CERTIFICATE OF APPROPRIATENESS

RE: Application Number 21-7359; 119 Garfield; Sugar Hill Historic District

SUGAR HILL MIXED-USE DEVELOPMENT

BULLETIN 3
OCTOBER 23, 2020

② EAST ELEVATION- JOHN R. STREET
1/8" = 1'-0"

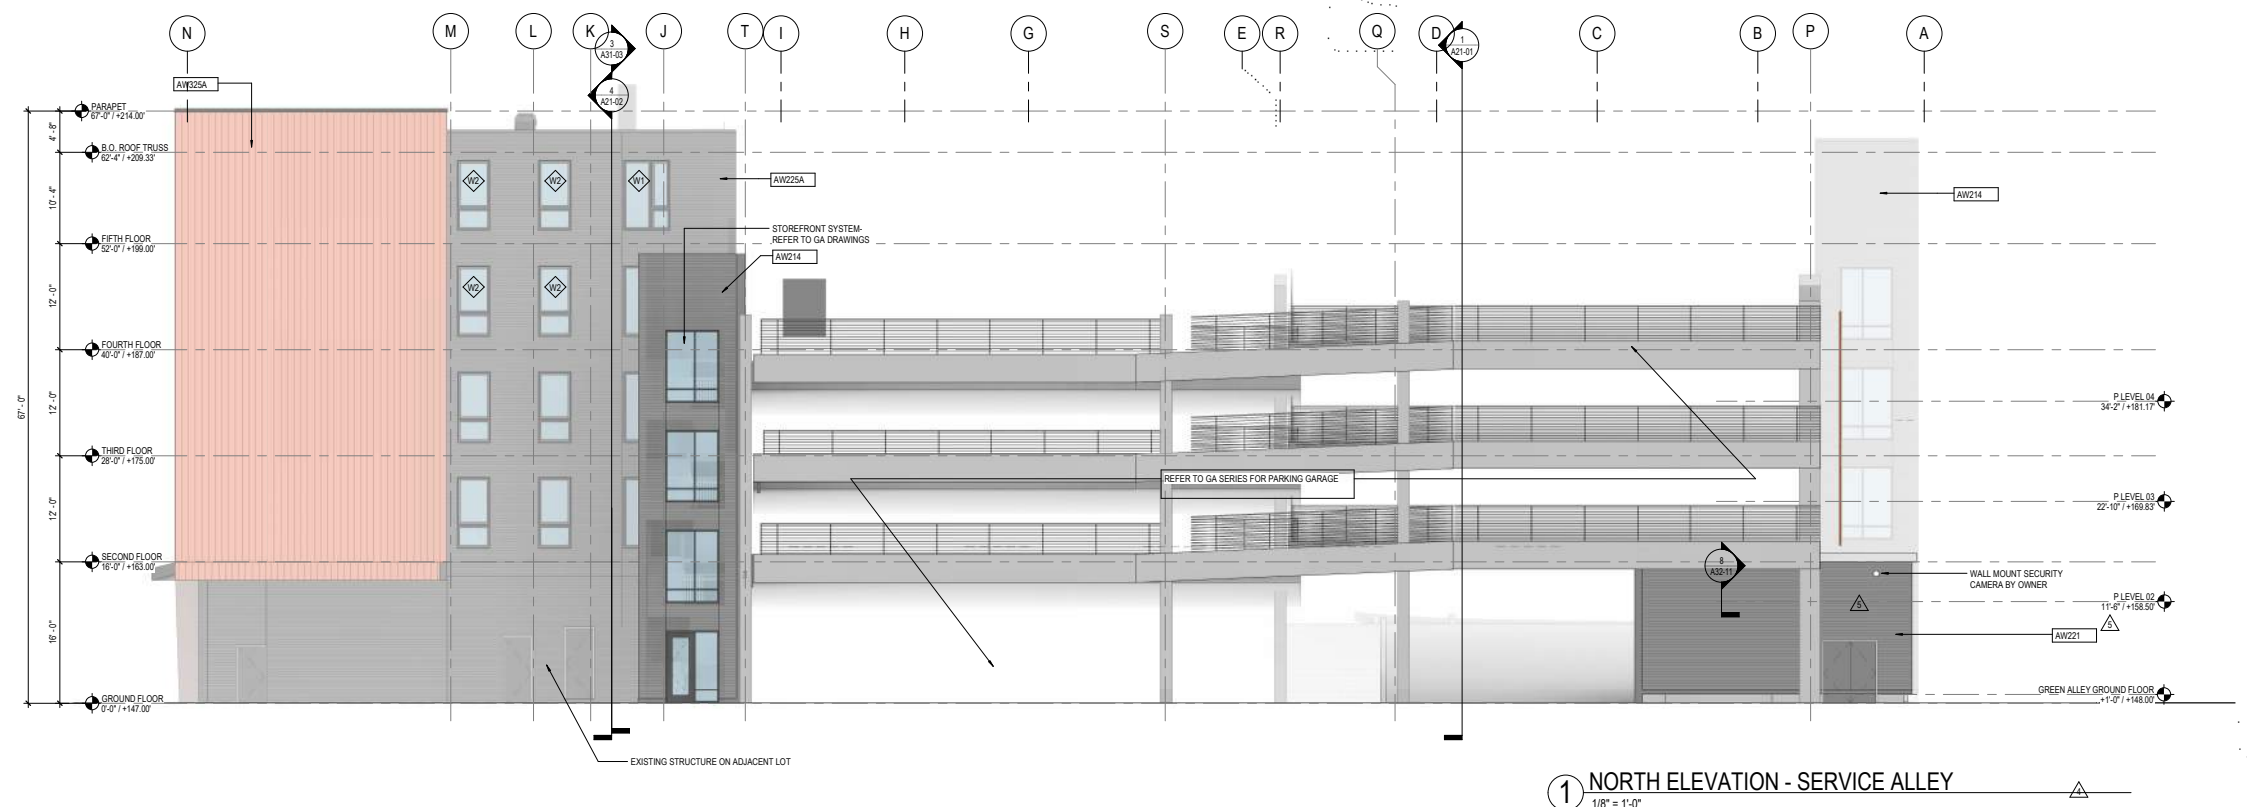
- SIDING SPEC FINALIZED
 - Hardie artisan 5/8" cement board rainscreen siding
 - Uses hardie support furring and trim components
 - Full warranty on siding system, not just the panel boards
 - Factory applied finish color - Foxy
- INSET PANEL REMOVED ABOVE WINDOWS
 - Painted hardie siding to match pattern
 - Panelized wood framing delays - in field framing of 2x4
 - Loss of wall insulating performance - NGBS Certification
 - Escalating wood prices
 - Hardie would not warranty the detail at "shoulders"
 - Hardie horizontal joint must occur at floor line
- ANDERSON 100 SERIES WINDOWS CHANGED
 - Andersen window sizes could not be customized
 - Andersen windows could not be mullered prior to shipping in field
 - Upgraded to commercial Quaker extruded vinyl windows
 - Higher quality commercial window
 - Steel reinforced frames and sashes
 - Finished, glazed and pre-assembled by Quaker

ELEVATIONS REVISED FOR VERTICAL SIDING REVISION- INCLUDING WINDOW REVISIONS

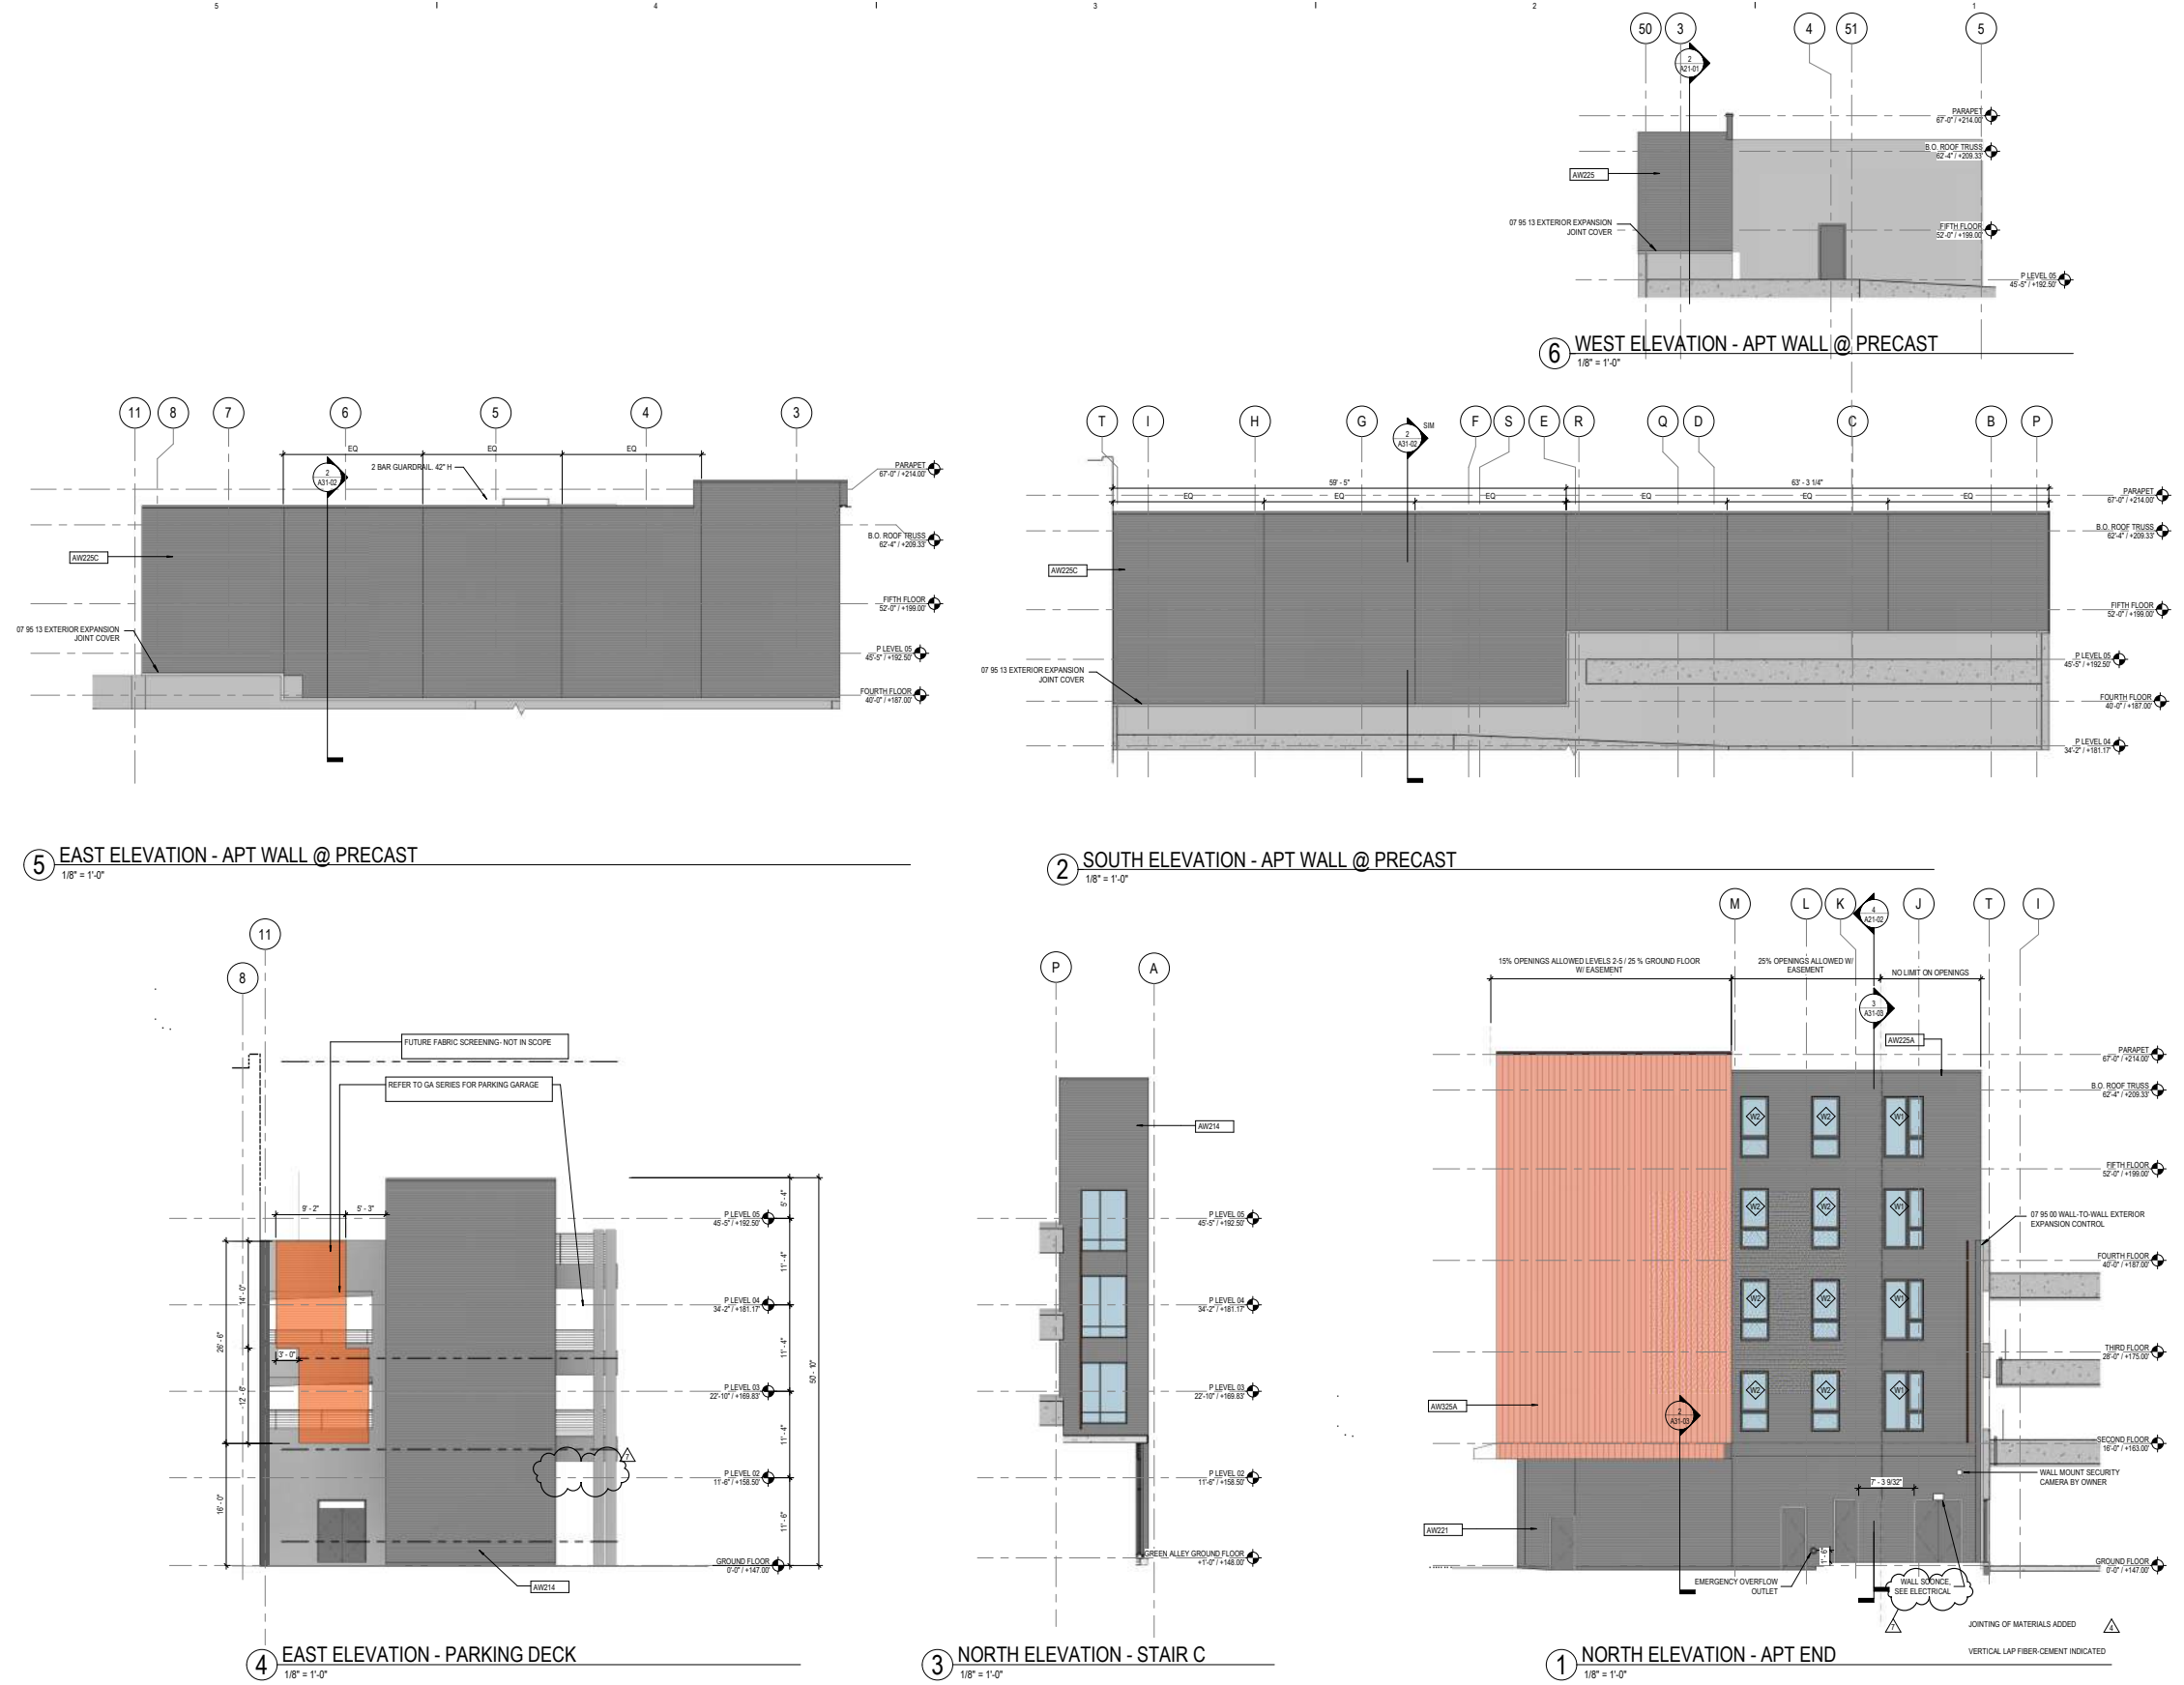
- SIDING SPEC FINALIZED
 - Hardie artisan 5/8" cement board rainscreen siding
 - Uses hardie support furring and trim components
 - Full warranty on siding system, not just the panel boards
 - Factory applied finish color - Foxy
- INSET PANEL REMOVED ABOVE WINDOWS
 - Painted hardie siding to match pattern
 - Panelized wood framing delays - in field framing of 2x4
 - Loss of wall insulating performance - NGBS Certification
 - Escalating wood prices
 - Hardie would not warranty the detail at "shoulders"
 - Hardie horizontal joint must occur at floor line
- ANDERSON 100 SERIES WINDOWS CHANGED
 - Andersen window sizes could not be customized
 - Andersen windows could not be mullered prior to shipping in field
 - Upgraded to commercial Quaker extruded vinyl windows
 - Higher quality commercial window
 - Steel reinforced frames and sashes
 - Finished, glazed and pre-assembled by Quaker

ELEVATION COMPARISON

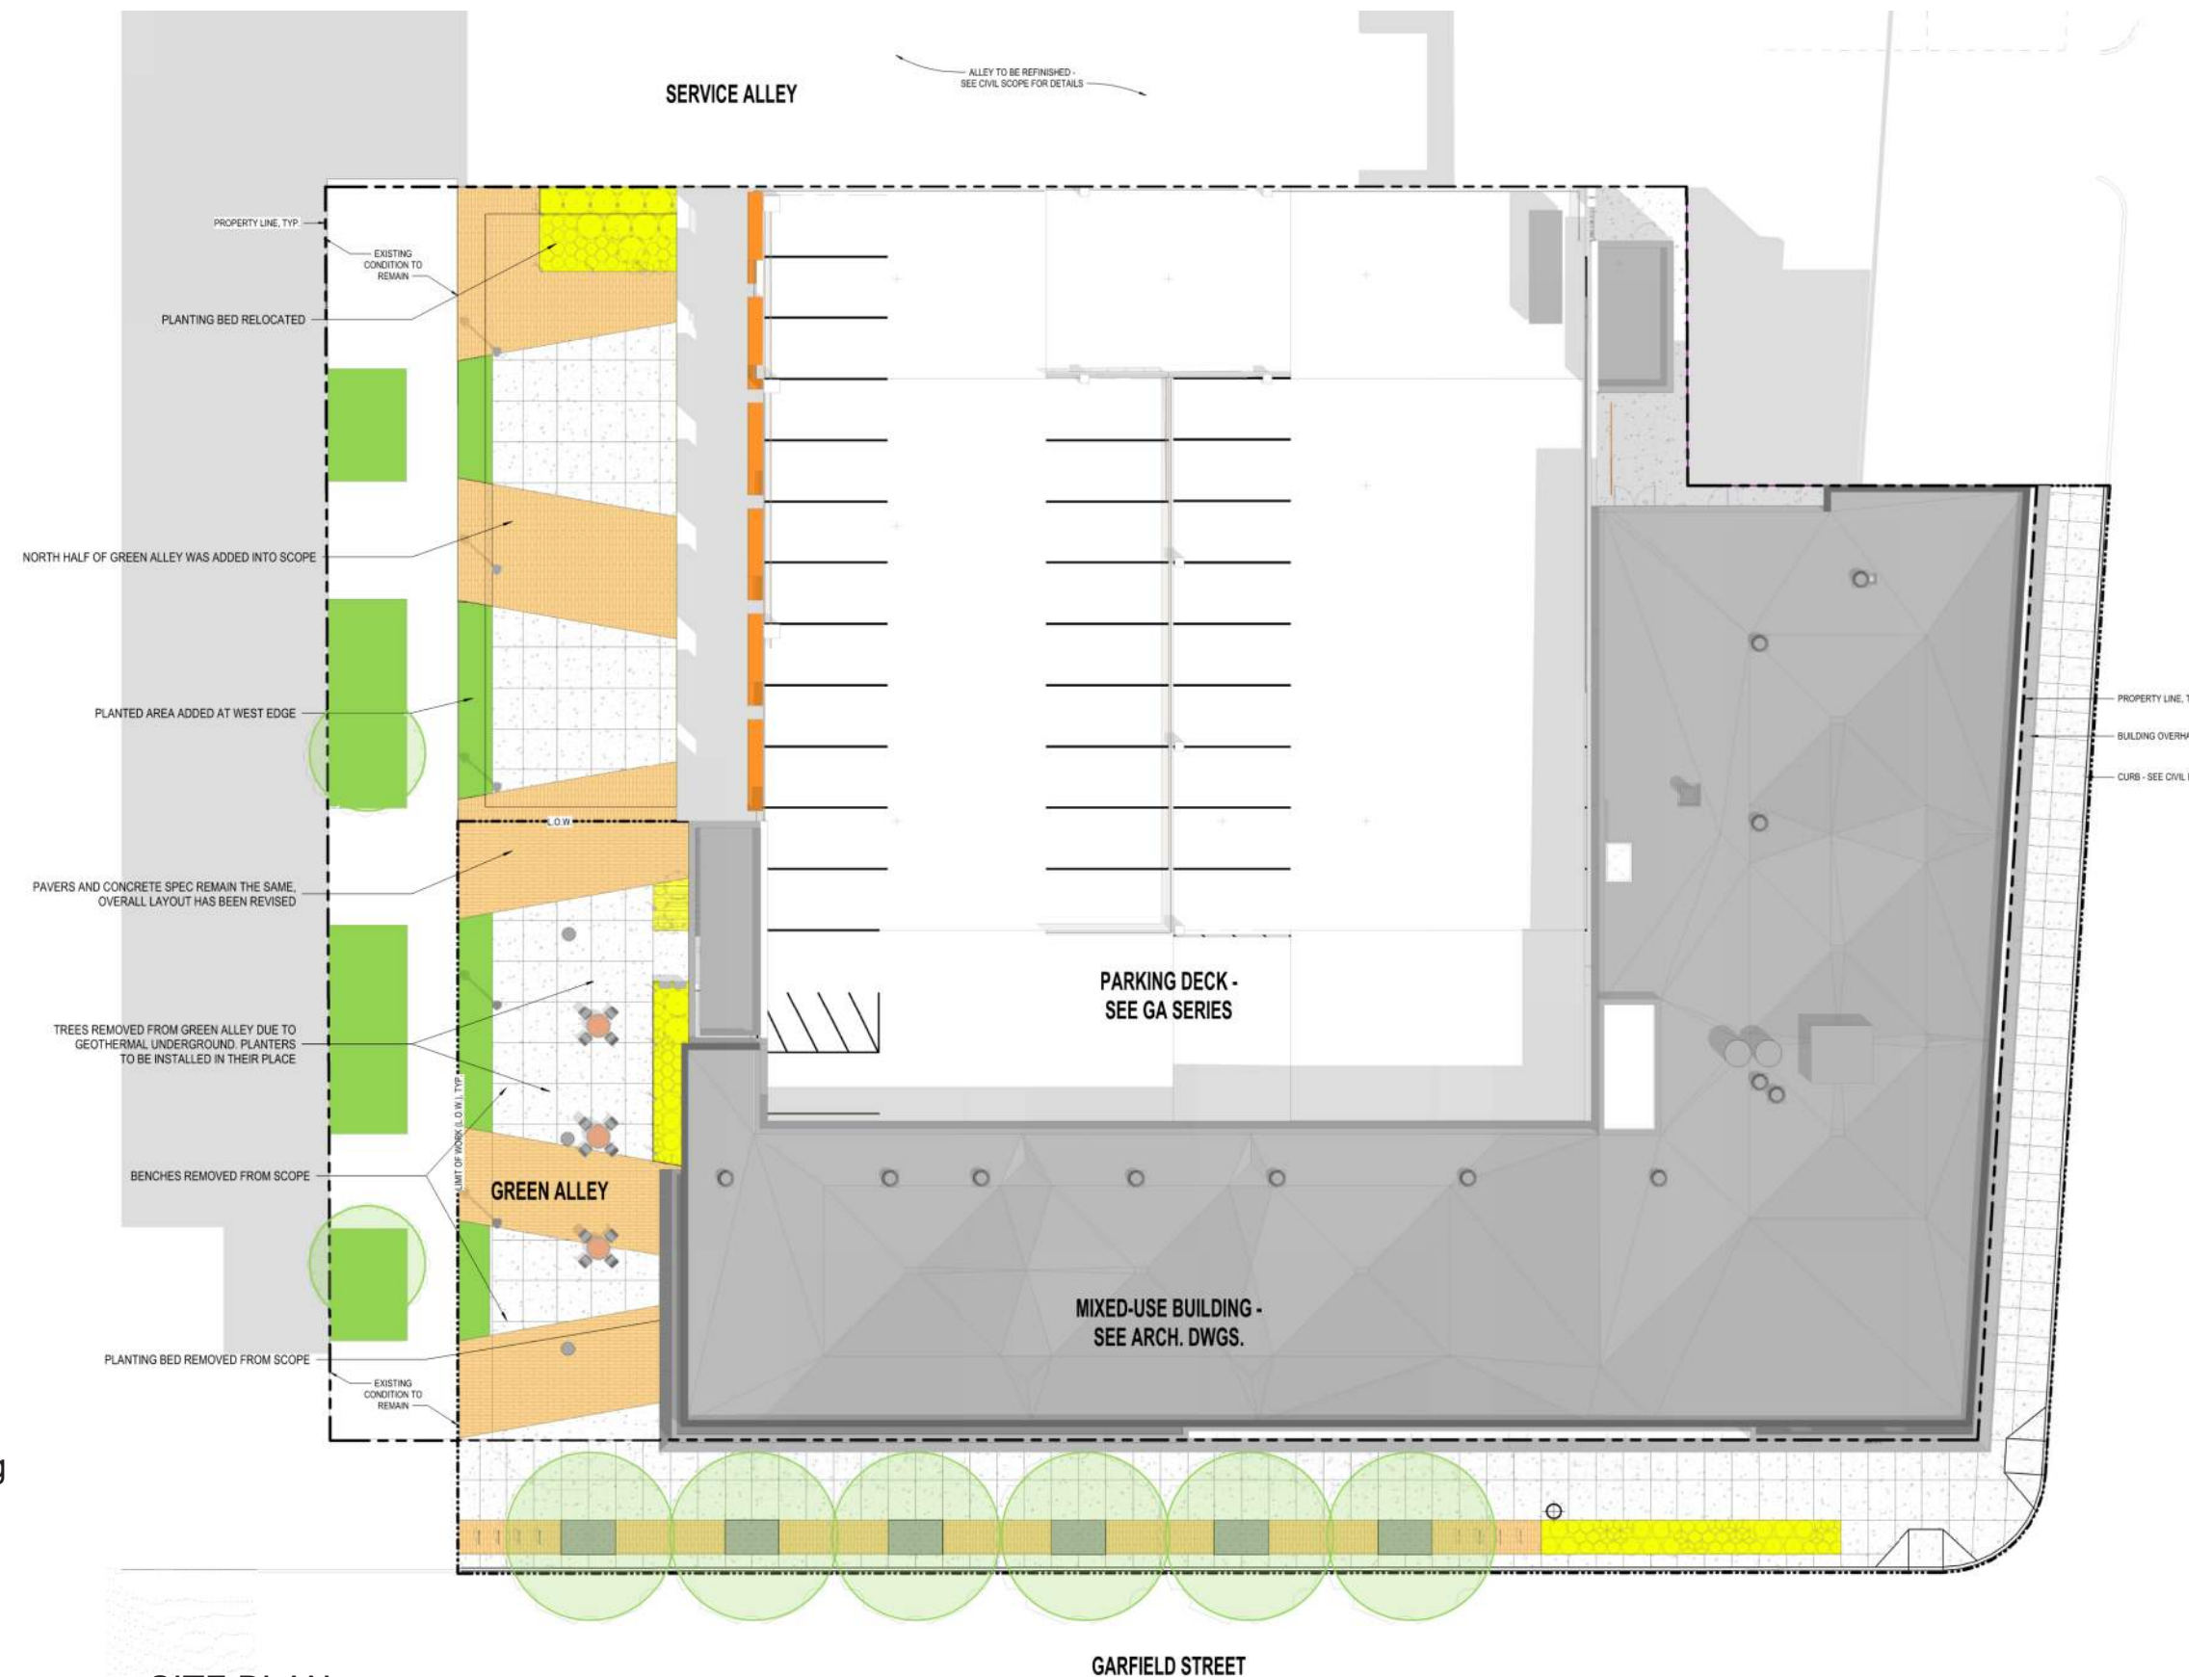
- **SIDING SPEC FINALIZED**
 - Hardie artisan 5/8" cement board rainscreen siding
 - Uses hardie support furring and trim components
 - Full warranty on siding system, not just the panel boards

- Factory applied finish color - Foxy
- **INSET PANEL REMOVED ABOVE WINDOWS**
 - Painted hardie siding to match pattern
 - Panelized wood framing delays - in field framing of 2x4

- Loss of wall insulating performance - NGBS Certification
 - Escalating wood prices
 - Hardie would not warranty the detail at "shoulders"
 - Hardie horizontal joint must occur at floor line

- **ANDERSON 100 SERIES WINDOWS CHANGED**
 - Andersen window sizes could not be customized
 - Andersen windows could not be mulled prior to shipping in field

- Upgraded to commercial Quaker extruded vinyl windows
 - Higher quality commercial window
 - Steel reinforced frames and sashes
 - Finished, glazed and pre-assembled by Quaker
